Subject: WATER IN THE INSTRUMENT AIR LINES AT THE CONDENSATE  
POLISHER CONTROL PANEL AND REGENERATION SKID RESULT-  
ING IN A LOSS OF FEEDWATER CONDITION IN UNIT #2 ON  
OCTOBER 19, 1977

THREE MILE ISLAND UNIT NO. 2

FIELD QUESTIONNAIRE NO. 1577

UNIT NO. 12  
 BURNS AND ROE, INC.  
 ENGINEERING CHANGE MEMO  
 (REV 12/75)

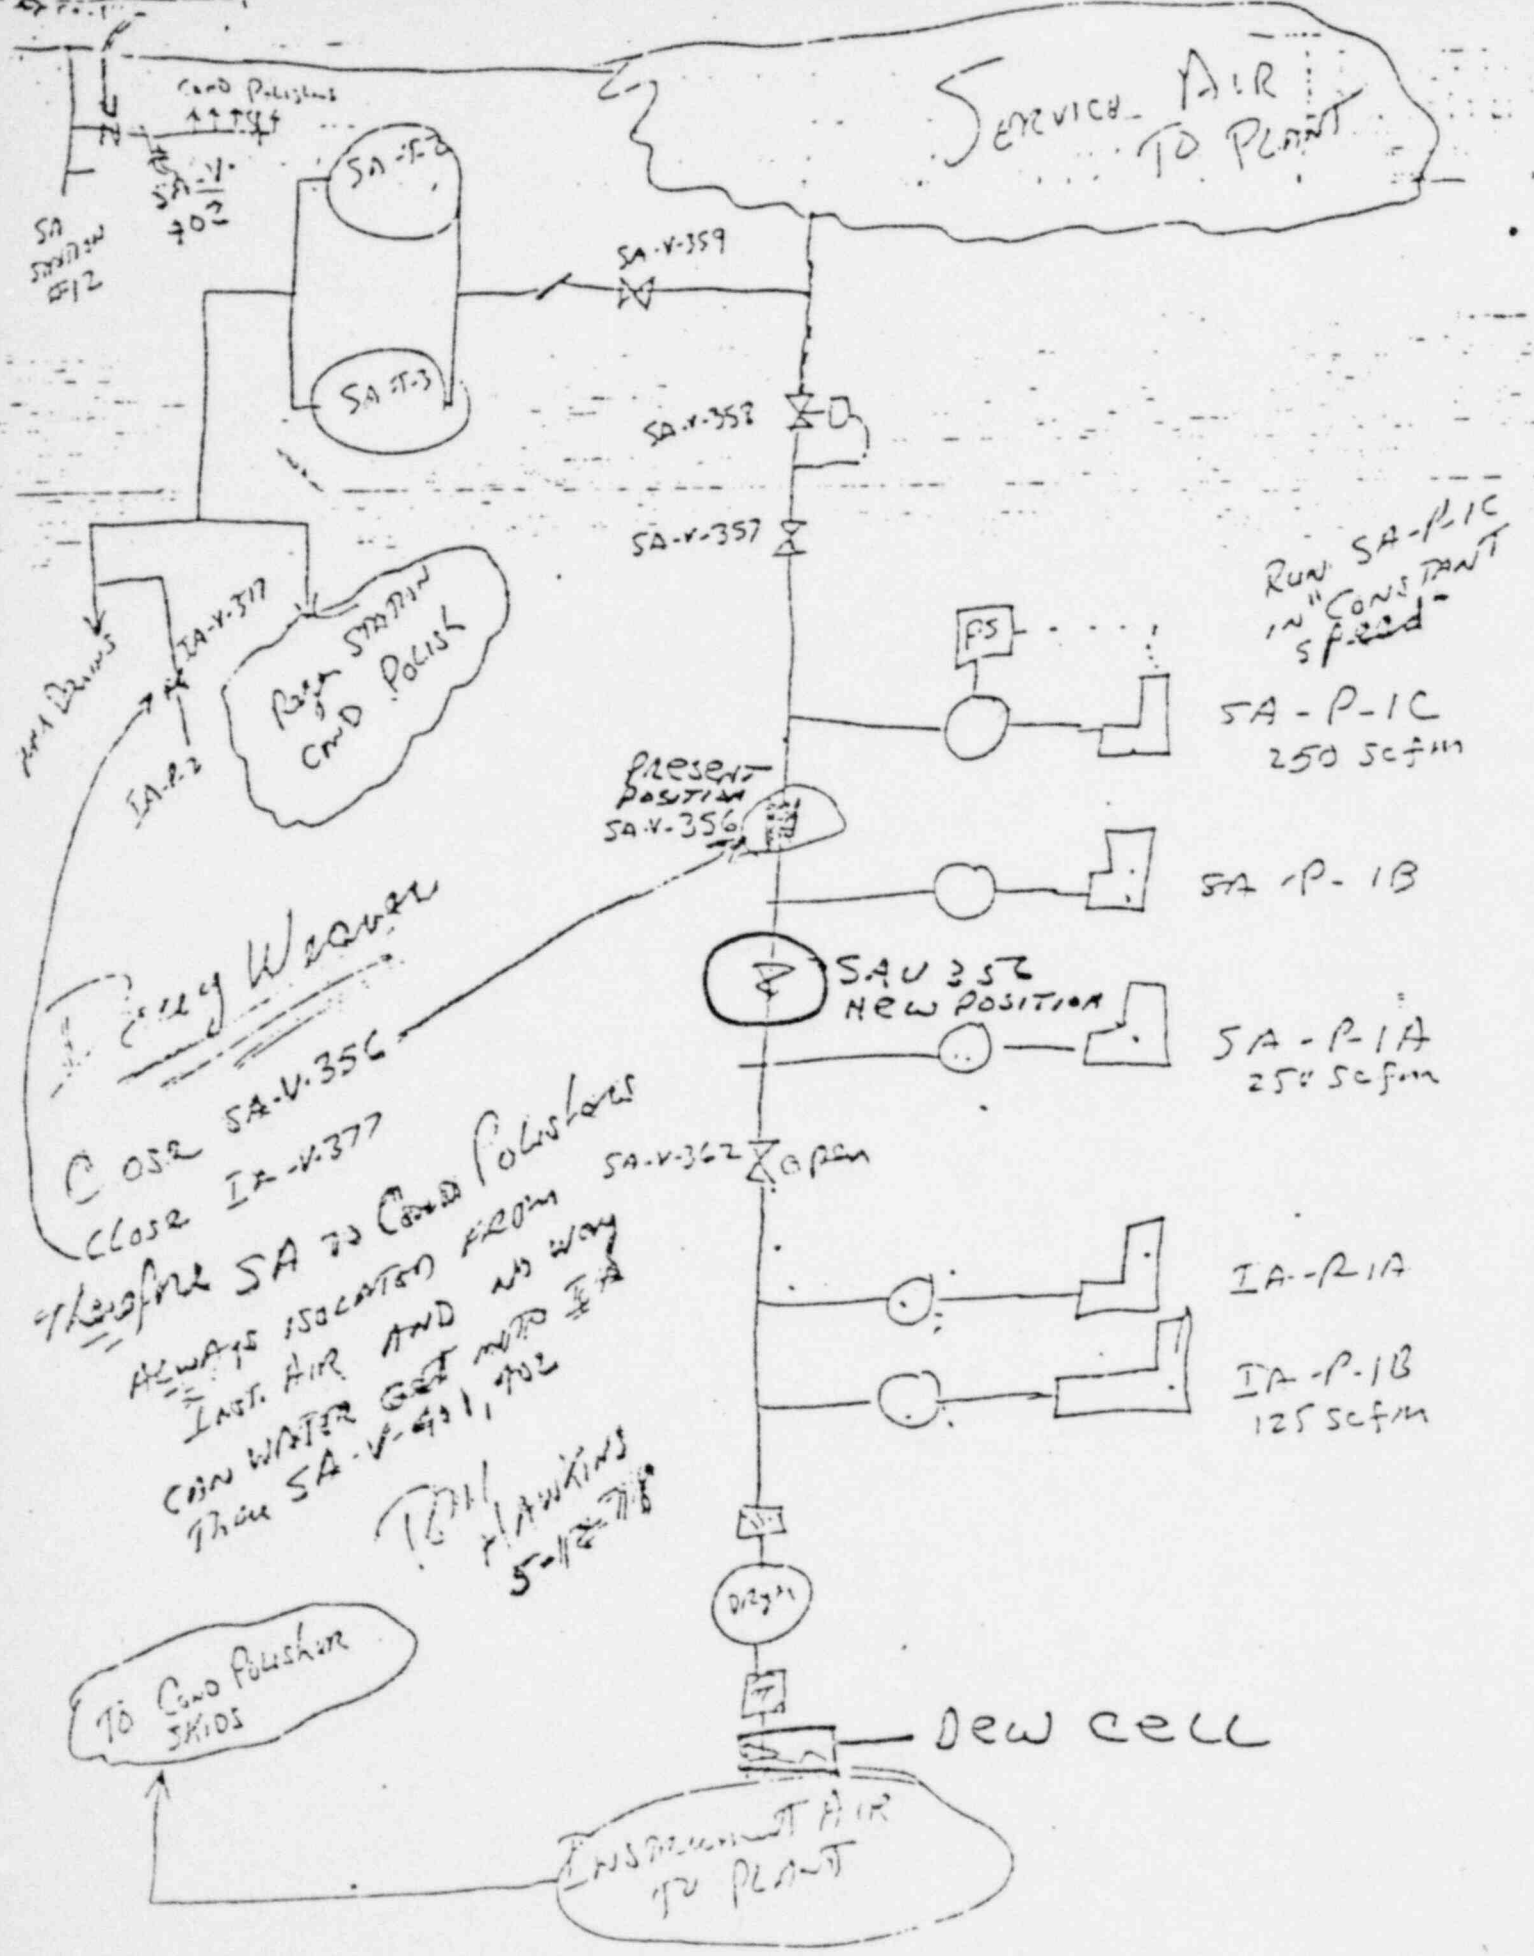
It's time to really do something on this problem before a very serious accident occurs. If the Polisters take themselves off line at any high power level the resultant damage could be very significant.

I have talked with Doug Weaver and we agree that a couple of things could be done to alleviate the problem.

1. COV12 - must be made an automatic valve that ~~opens~~ on High Polister OP  
OPENS
2. SAV 356 - Move valve to between SA-P-1A and SA-P-1A. Keep this valve shut at all times to isolate SA. + I.A.
3. Install inline Dew cell instrument downstream of air dryer. This should be made to alarm and record.

Run SA-P-1C  
in "CONSTANT  
speed"

CLOSE SA-V-356  
close IA-V-377  
Therefore SA TO COND POLISHERS  
ALWAYS ISOLATED FROM  
INST. AIR AND NO WAY  
CAN WATER GET INTO IA  
THROUGH SA-V-401, 402  
TOTAL PLANNING  
5-11-78

Attachment 1 of 2  
 ECM No. S-4512

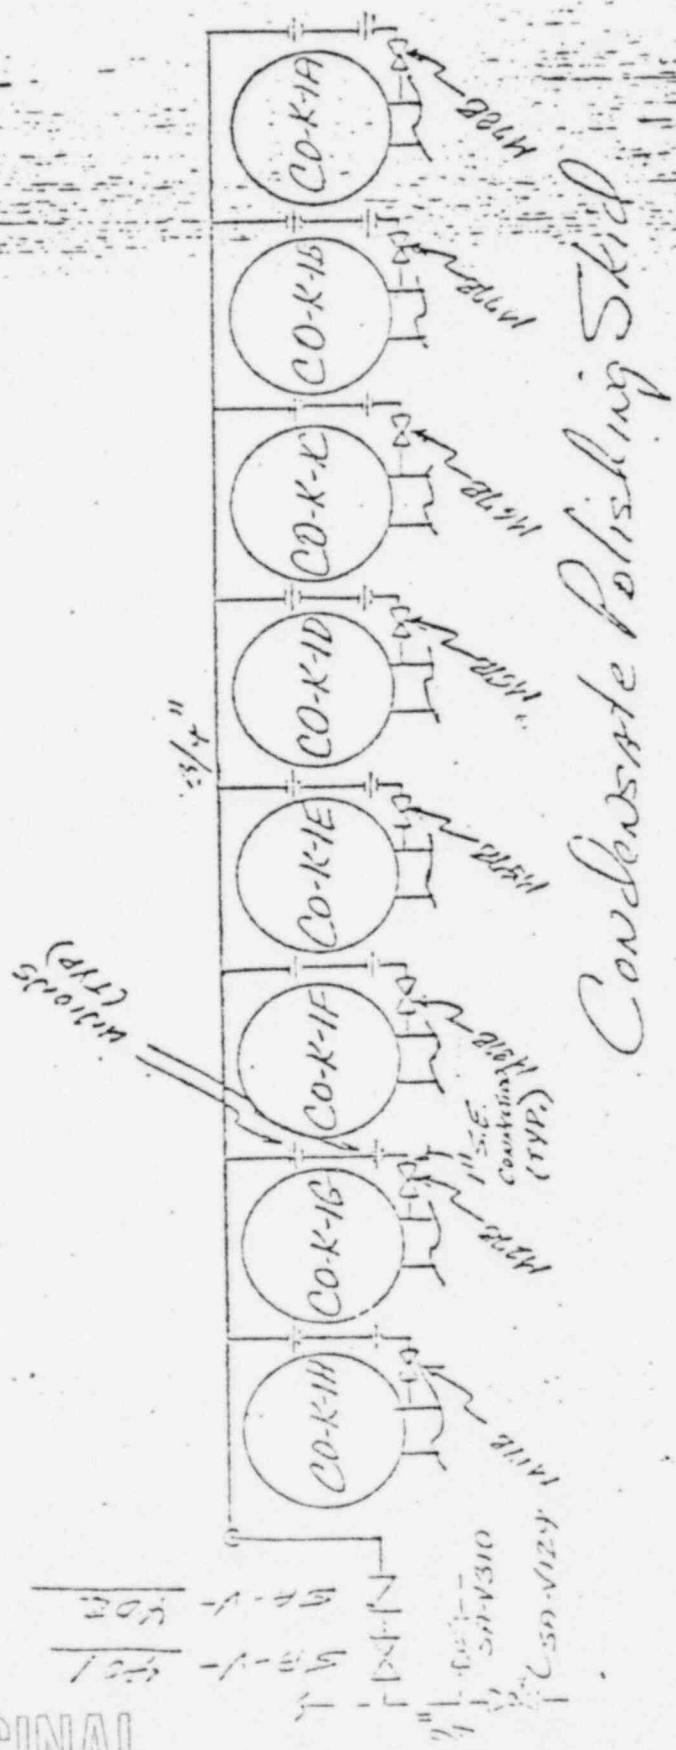
UEC START-UP TO CONNECT 3/4" Line spec. 150-1, piping at S.A. STA. NO. 12 and field route to a 3/4" C.S. gate valve and check valve. From the check valve field run the header and branch lines to each Condensate Polisher valve M17B then M97B. (see attachments 1 and 2 of 2).

B&R to change value list to retag:  
 S-726-1-473 (3/4" C.S. gate s.w.) to SA-V-LATER  
 S-726-1-244 (3/4" C.S. check s.w.) to SA-V-482.

GPU Request to provide permanent S.A. supply to the bottom of each Condensate Polisher to lift & fluff resins prior to sluicing to Regeneration Station.

All Piping To Be 3/4" 450-1  
 And Field Run By MEC STARTUP
